Renovation, ADA Compliance, HVAC and Electrical Updates to the Theater, Exhibit Hall and Associated Tertiary Spaces at the Interpretive Center at Falls of the Ohio State Park, Clark County

Addendum No. 1

Re **Falls of the Ohio Interpretive Center Renovation**
201 West Riverside Drive
Clarksville, IN 47129
BBA Project No. 1305.0

Date October 28, 2014
From Clark Barnette
File 1305_ADD1 Narrative Oct 28 14.docx

2	Lighting
N.T.S.

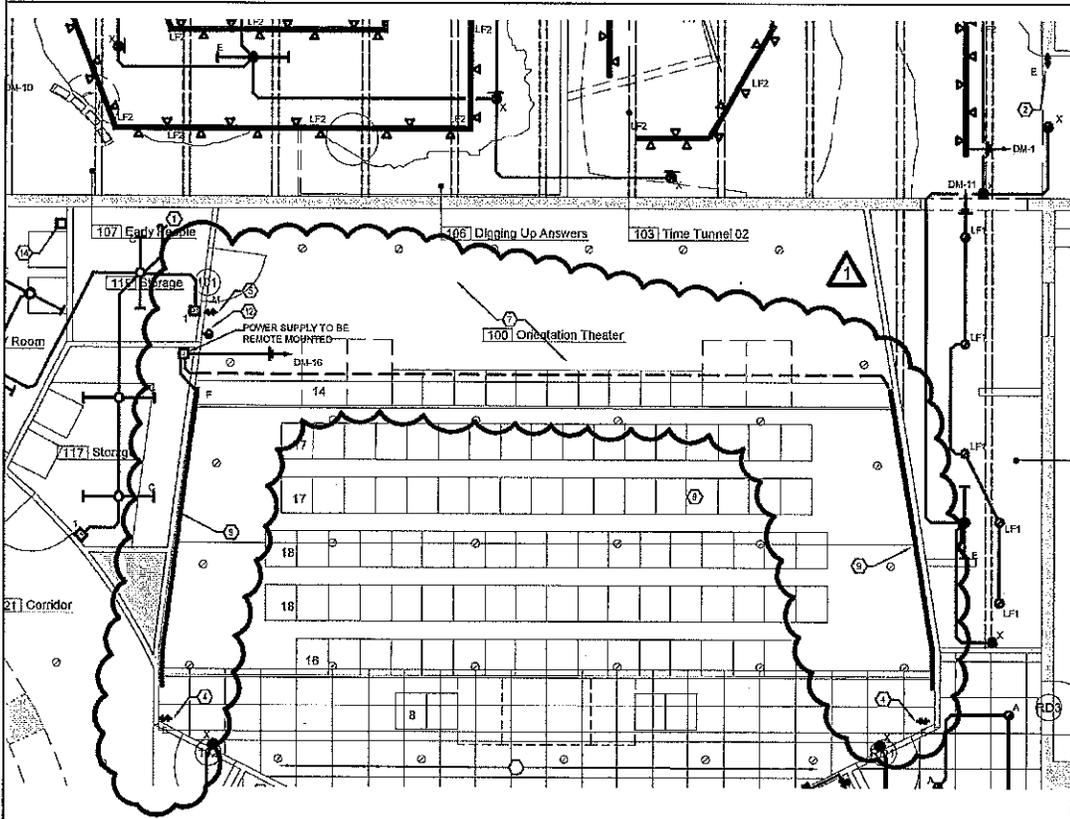
Aisle Lighting at 100 Orientation Theater - Refer to Sheet E1.1.

Reference attached Drawing E1.1A for revised lighting requirements at Orientation Theater 100.

SHEET NOTES ○

9. PROVIDE AND INSTALL TYPE "F" LINEAR AISLE LIGHTING AT FLOOR. TYPE "F" SHALL BE 16'-0" LINEAR RUN OF TEMPO INDUSTRIES (33-06-BK-1-22K-B / PWR-T0-150-12/2) . FIXTURE TO BE POWERED BY REMOTE 120/12V POWER SUPPLY TO BE MOUNTED AT STORAGE 117. COORDINATE EXACT MOUNTING HEIGHT AND LOCATION WITH ARCHITECT PRIOR TO INSTALL. REMOVE EXISTING POWER FEED TO SEAT MOUNTED AISLE LIGHTING COMPLETE.

2	Power
N.T.S.

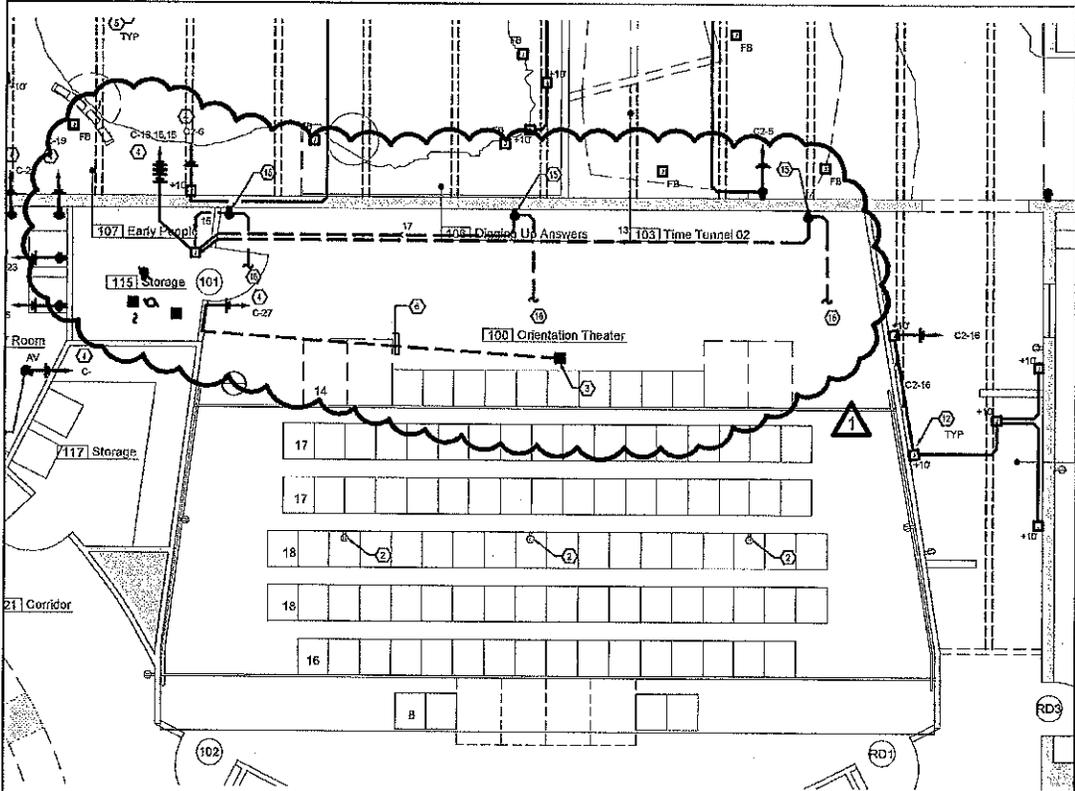
Exhibit Connections - Refer to Sheet E2.1.

Where j-boxes for 120V connections are indicated for Scenic Casework, Exhibit Displays, and/or AV equipment contractor shall coordinate box placement prior to rough-in and provide final connection with maximum 6'-0" flex. Coordinate all rough-in locations and connection requirements with Exhibit Designer (Solid Light).

SHEET NOTES

- 15. RAISE EXISTING OUTLET TO APPROPRIATE HEIGHT ABOVE NEW FINISHED FLOOR LEVEL AND REFEED EXISTING BRANCH CIRCUIT DISRUPTED BY DEMOLITION.
- 16. PROVIDE CONNECTION TO EXISTING CONDUIT ROUTED BELOW SLAB TO NEXT DEVICE AND EXTEND NEW BRANCH CIRCUIT WIRING TO DEVICE AS REQUIRED.

2	Electrical Demolition
N.T.S.

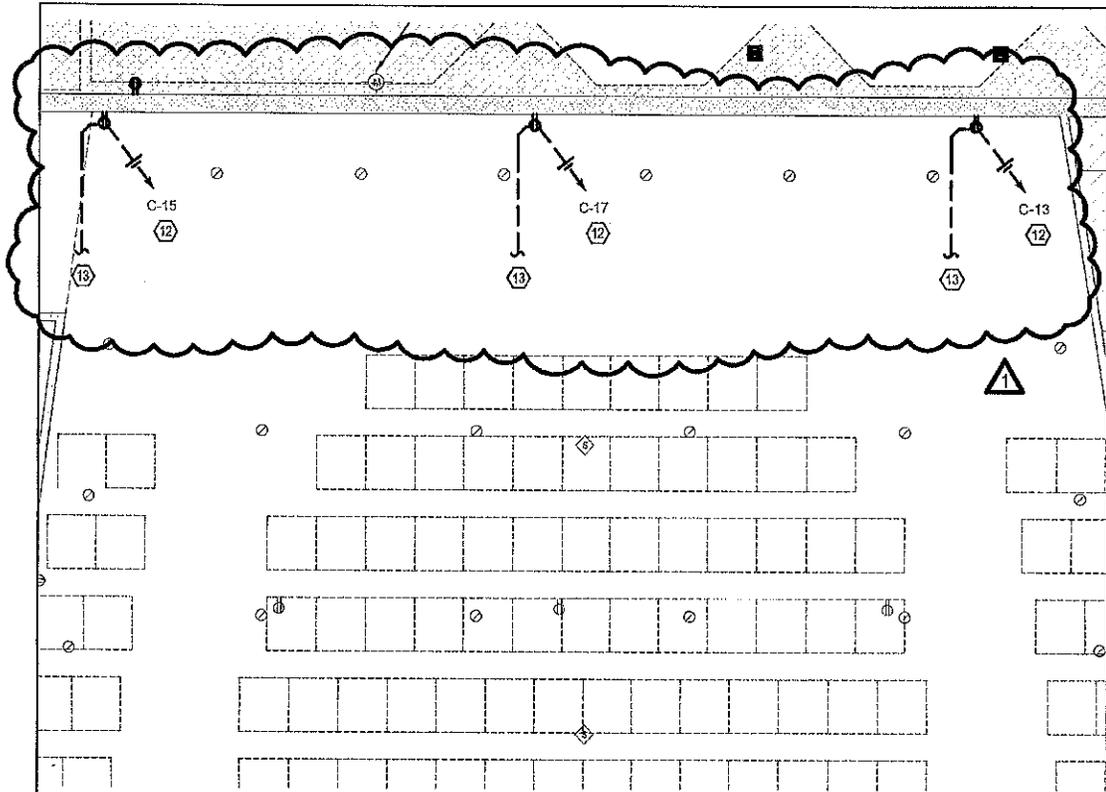
Auditorium Receptacles - Refer to Sheet ED1.1.

Three (3) existing duplex receptacles located at front wall of 100 Orientation Theater will be below slab after new floor is poured. Existing outlets are fed from below slab. Remove existing branch circuit wiring feeding existing receptacles complete. Remove existing branch circuit wiring feeding next device downstream complete. Reference attached Drawing ED1.1A for additional details.

SHEET NOTES

12. EXISTING BRANCH CIRCUIT HOMERUN ROUTED UNDERSLAB TO BE DISRUPTED. REMOVE HOMERUN WIRING AS REQUIRED, CONDUIT TO REMAIN.
13. EXISTING BRANCH CIRCUIT ROUTED BELOW SLAB TO NEXT DEVICE TO BE DISRUPTED. REMOVE WIRING COMPLETE, CONDUIT TO REMAIN.
